REGULAR MEETING OF THE LAKE ORION PLANNING COMMISSION

Monday, February 5, 2024

TOPIC: PC-23-07 - Peninsula Site Plan Review

Please see the attached revised site plan documents addressing the review comments from Nowak and Fraus's review letter dated December 14, 2023, Orion Township Fire Department review letter dated December 18, 2023, and Mckenna review letter dated December 19, 2023 (responses are *italicized*):

UTILITY PLAN & PROFILE

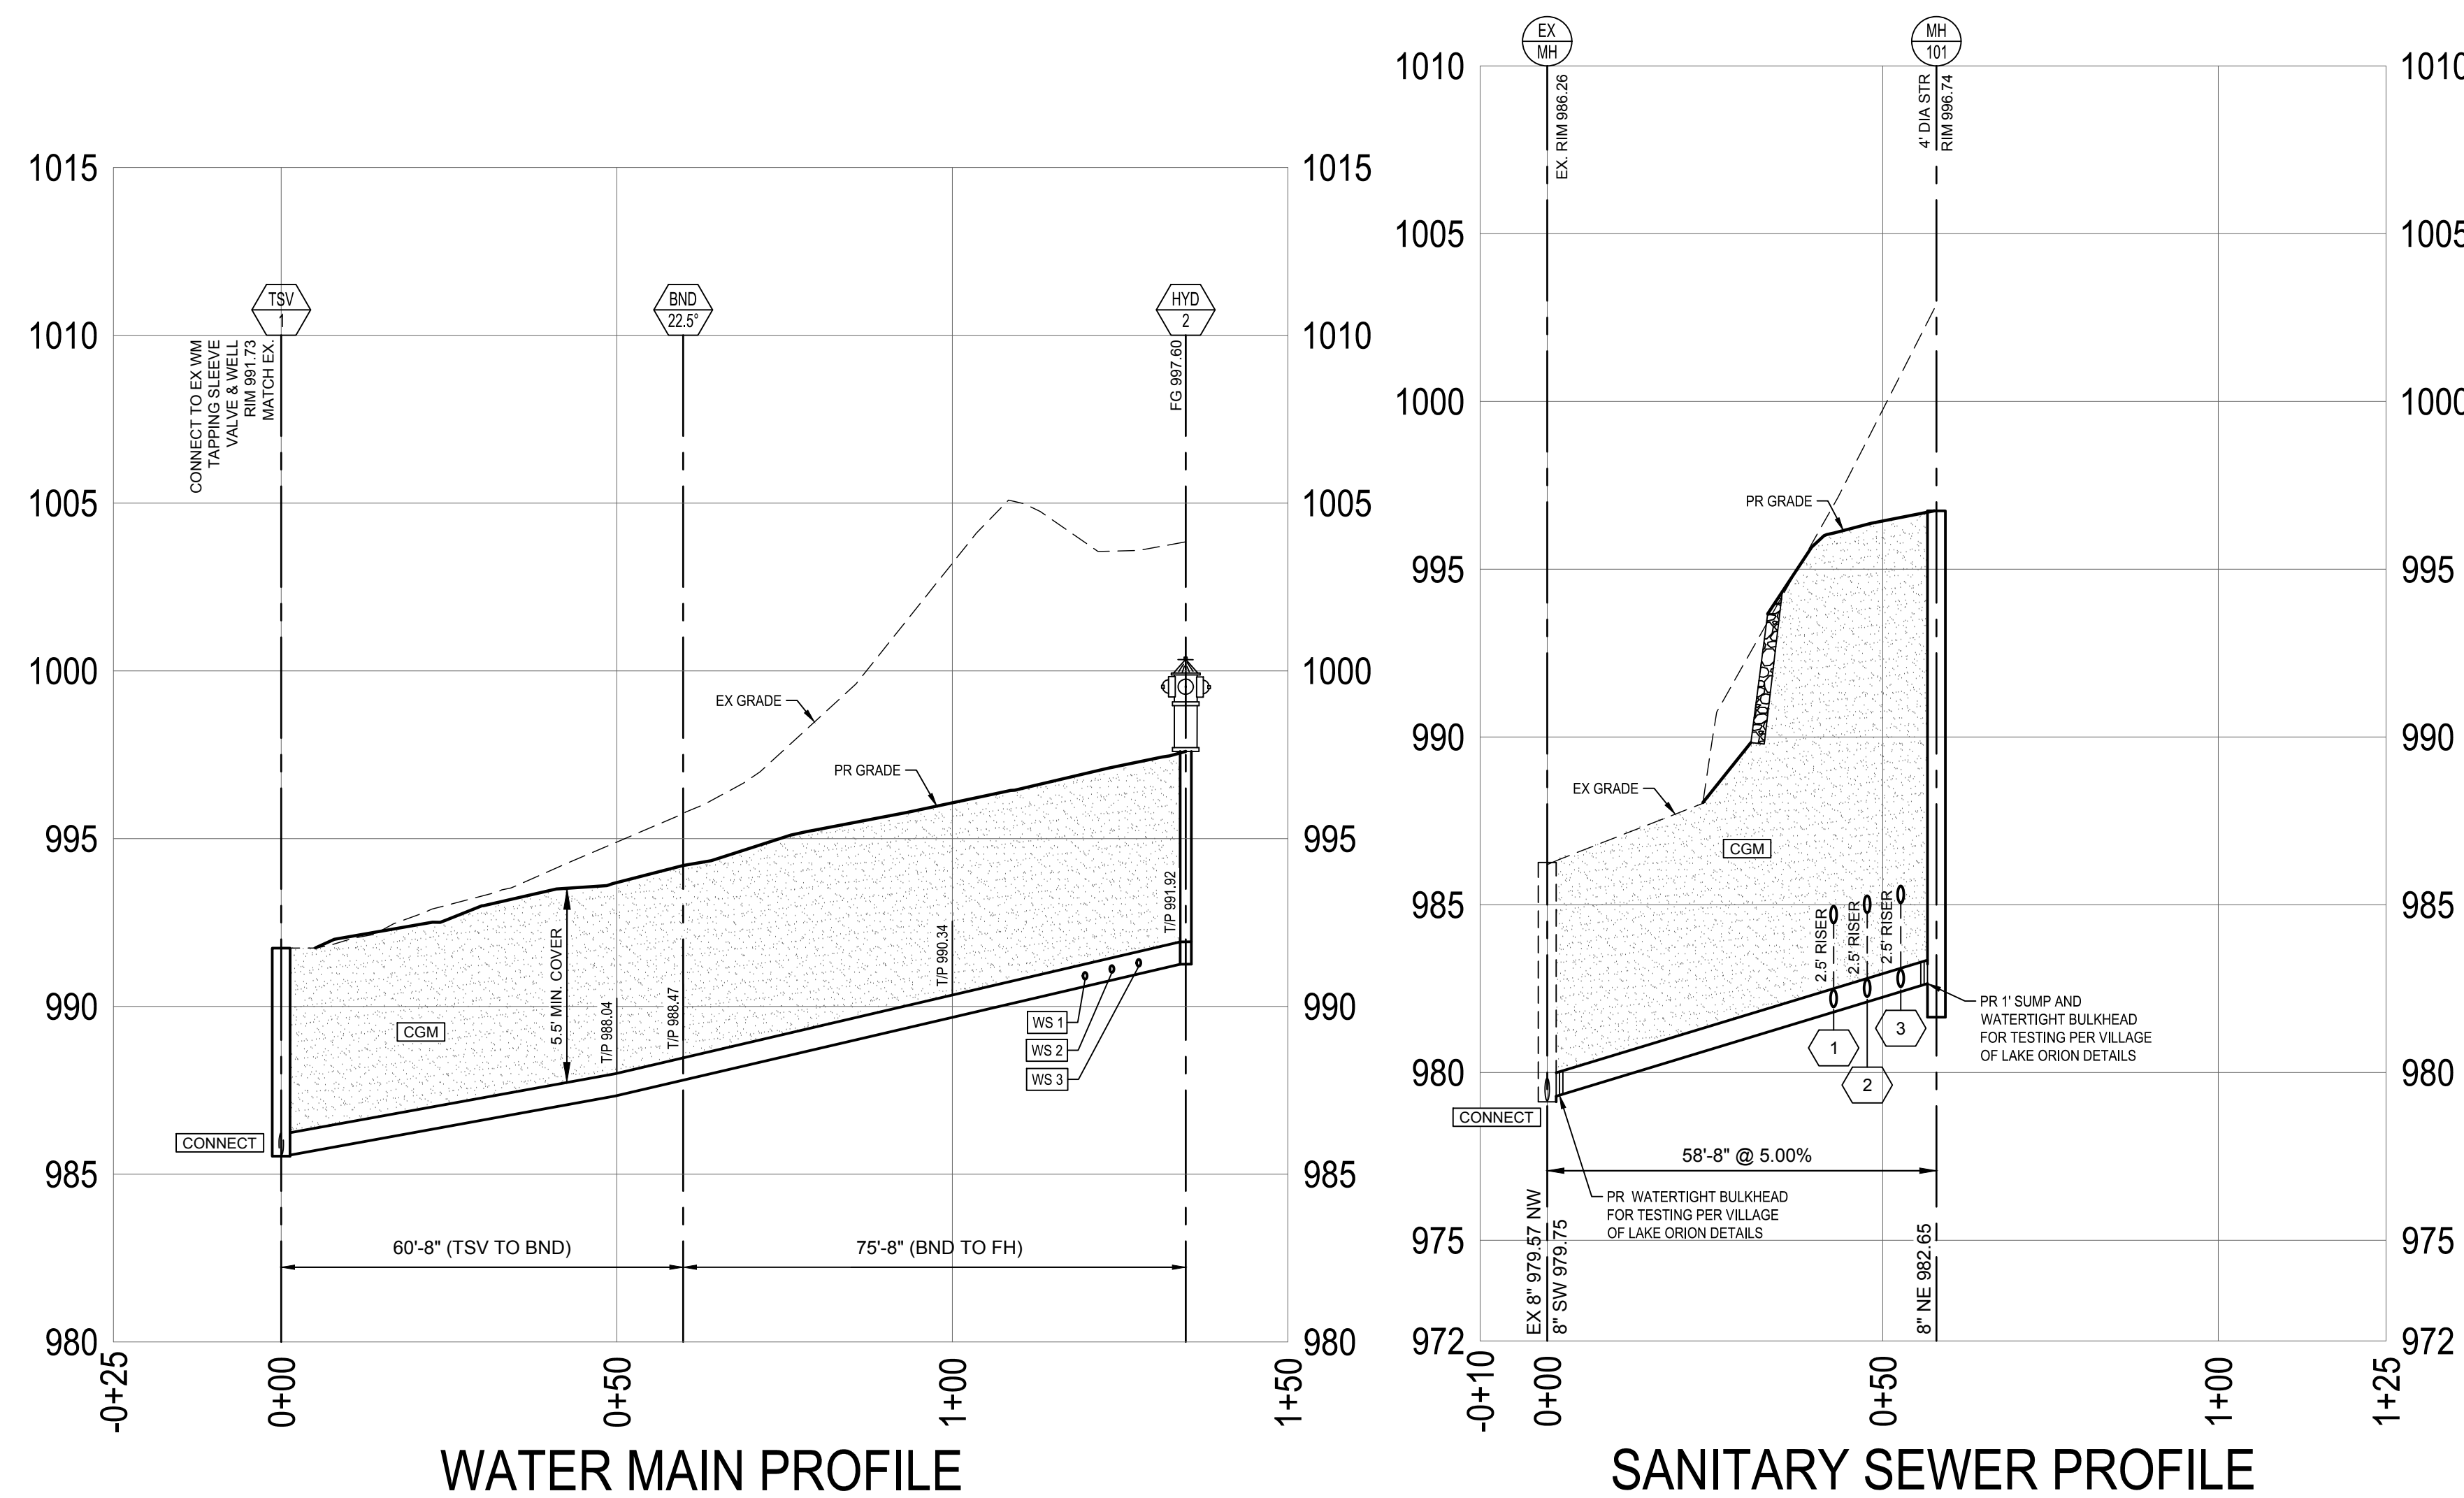
17. We note that the revised proposed sanitary sewer now connects to the existing manhole with an acute angle between pipes, which is generally not sound practice.
With the revised water location, sanitary has been adjusted to an approximate 90 degree angle.

LANDSCAPE PLAN

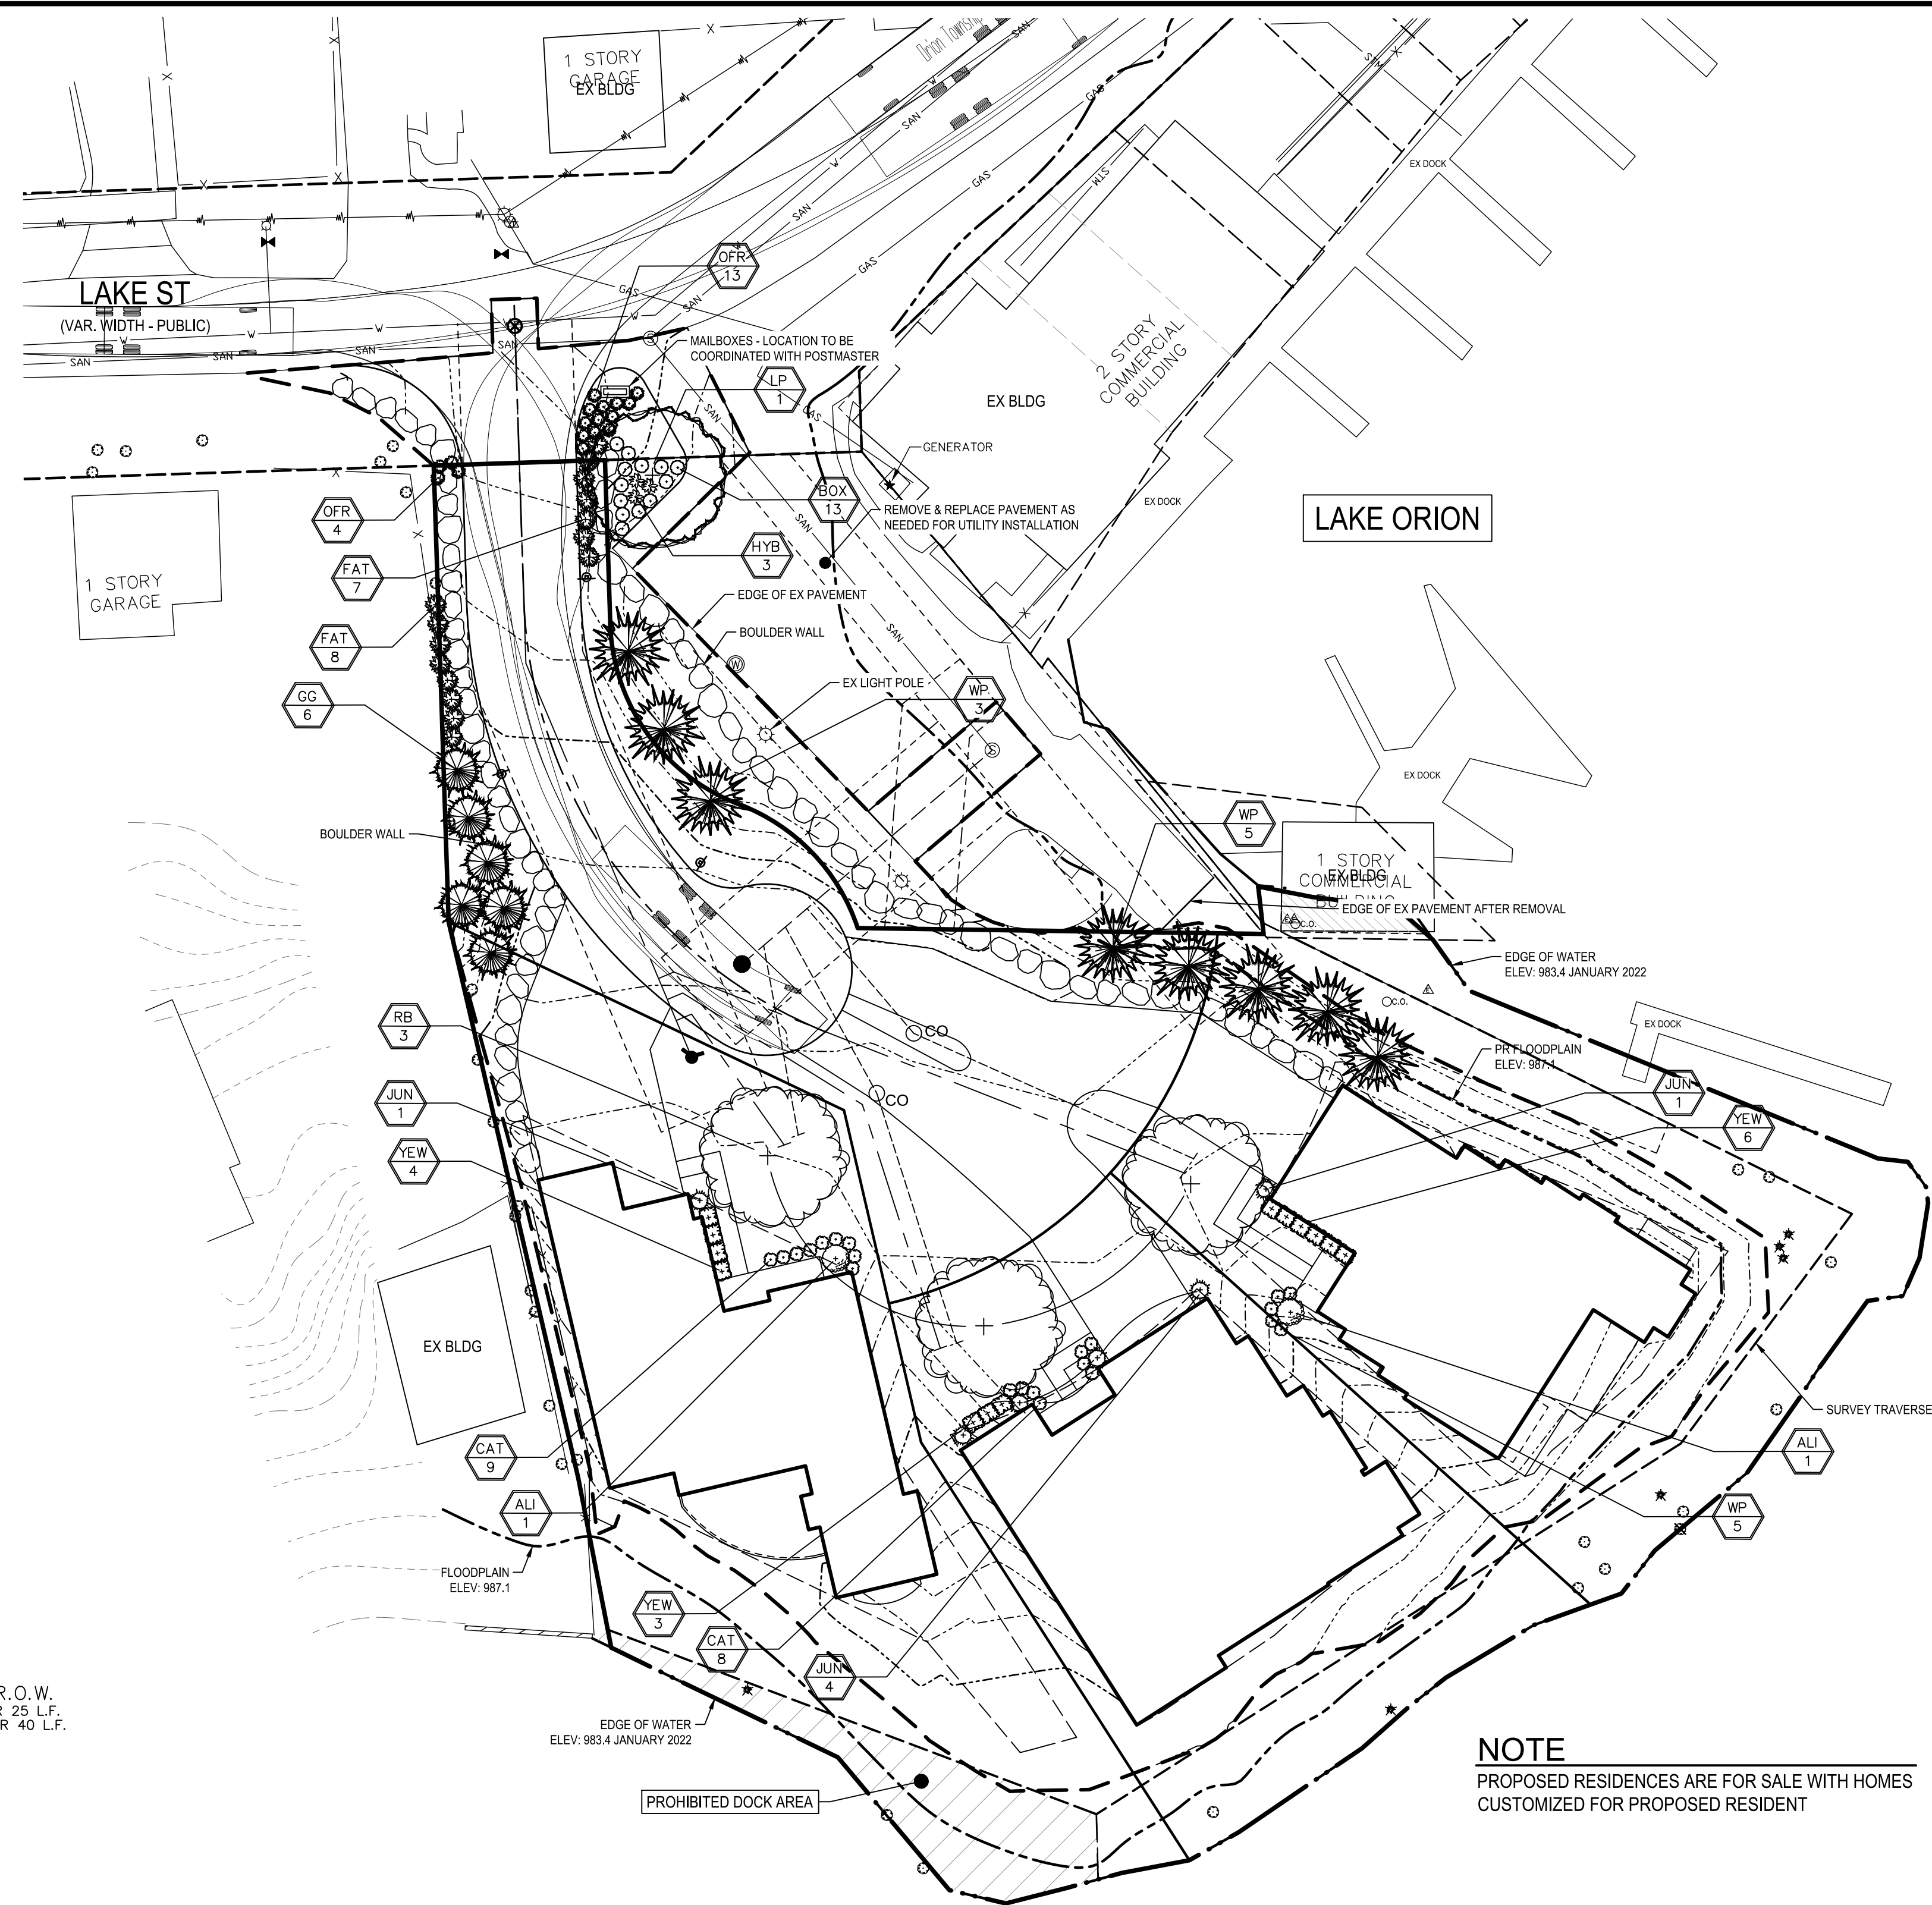
20. The landscape plan includes many proposed plantings outside the limits of this property. If this is acceptable to the Village, we recommend a permanent easement for landscaping be required from the adjacent parcel, regardless of any current common ownership.
Easement will be provided prior to construction.

21. The landscape plan calls for planting "Encore Maiden Grass" in the Lake Street right-of-way. Research indicates this specimen may grow 47" to 53" tall, exceeding the maximum 30" height for plantings in clear vision areas. Additionally, the arborvitae proposed within 10' of the Lake Street right-of-way, the least distance defined for clear vision if Portside Drive is treated as a driveway rather than a street (streets require 20'), grows to over 6' in height. *Plantings have been revised.*
